Crystal River Nuclear Plant
Docket No. 50-302
Operating License No. DPR-72

Subject: Crystal River Unit 3 – Response to Request for Additional Information Regarding Relief Requests #07-001-SS, Revision 0, Alternate Examination Criteria for the Reactor Vessel Support Skirt to Perform Limited VT-3 Visual Examination on 3 areas 120 Degrees Apart on the Inside Surface in Accordance with 10 CFR 50.55a(a)(3)(i), TAC No. MD7737

Response to Request for Additional Information

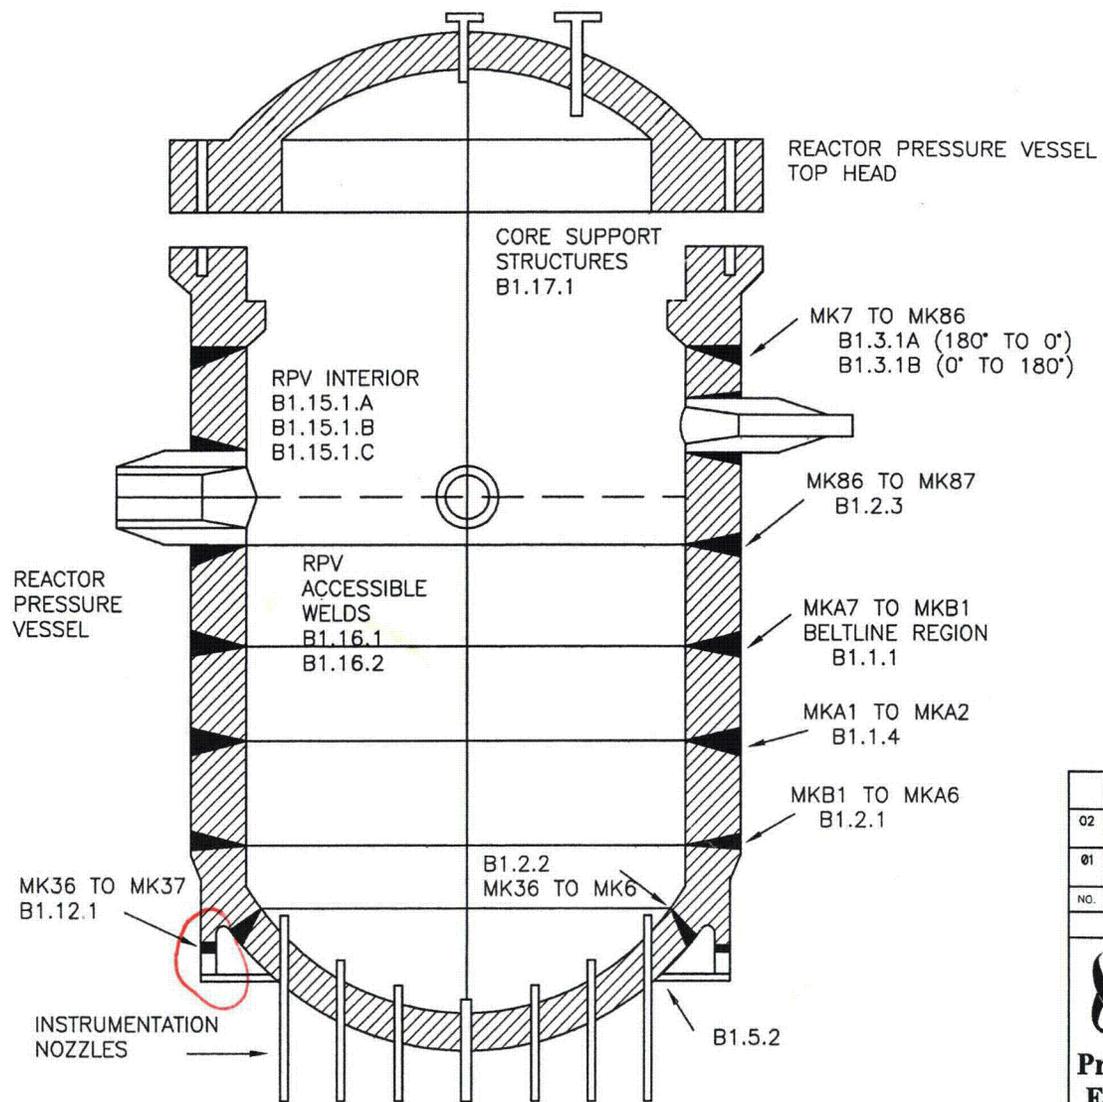
The American Society of Mechanical Engineers (ASME) Code, Section XI, Examination Category F-A, Item F.130 requires a 100% VT-3 visual examination of weld and mechanical connections at intermediate joints in multi-connected integral and non-integral supports, as defined by Figure IWF-1300-1. The licensee has proposed performing an alternative VT-3 visual examination on 10% of the reactor vessel (RV) support skirt for the fourth 10-year inspection interval for CR3. The proposed approach utilizes the identical approach from previous inspection intervals. The RR (98-003-II) for the third CR3 10-year ISI interval was authorized in the Safety Evaluation Report dated August 5, 1999. Relief was requested based on the radiation conditions below the RV, which would result in significant radiation exposure to inspection and support personnel. Because there have been substantial improvements in inspection techniques since the previous inspection interval, the staff requests that the licensee address the potential for increase in visual examination of the RV skirt through the use of improved state-of-the-art inspection techniques.

The outside surface of the weld is restricted from access by a welded seal plate in the refueling cavity. This plate would have to be removed and a person would have to be lowered down between the reactor vessel and the shield wall to remove the insulation and perform the inspection of the support skirt weld. An optional access point for the inspection would be to remove the concrete plug allowing access from below. This option involves the removal of 42 cubic feet of 5000 psi concrete, which is further complicated by the fact that the plug is overhead and there is insufficient room for jackhammers to be used. Therefore, only the inside surface of the support skirt weld is reasonably accessible, which automatically limits the examination to no more than 50%.

The areas inspected are reviewed each time to note any trends of degradation. Any mechanism which could damage the vessel would be evident at these three locations examined and not confined to small areas around the vessel. If the entire vessel shifted, then the damage to the bolting, support skirt or associated weld would be visible over a majority of the examination area.

It is expected that more than 10% of the inside support skirt weld is inspected during the required VT-3 visual examination, but there is no accurate method of measurement. Therefore, CR-3 cannot commit to a larger percentage of the inspection area. The area is too confined to get a measurement device in place. The last time this examination was performed was in conjunction with the bare metal visual inspection of the bottom reactor vessel head during Refuel Outage 13 in 2003.

CR-3 will perform a VT-3 examination of the reactor vessel support skirt weld, to the extent practical, when maintenance or other activities remove the insulation covering the support skirt weld. This can be performed in conjunction with the bare metal visual inspection of the bottom reactor vessel head. The inspection is performed with a pole mounted camera and enables a long reach around the circumference of the support skirt.
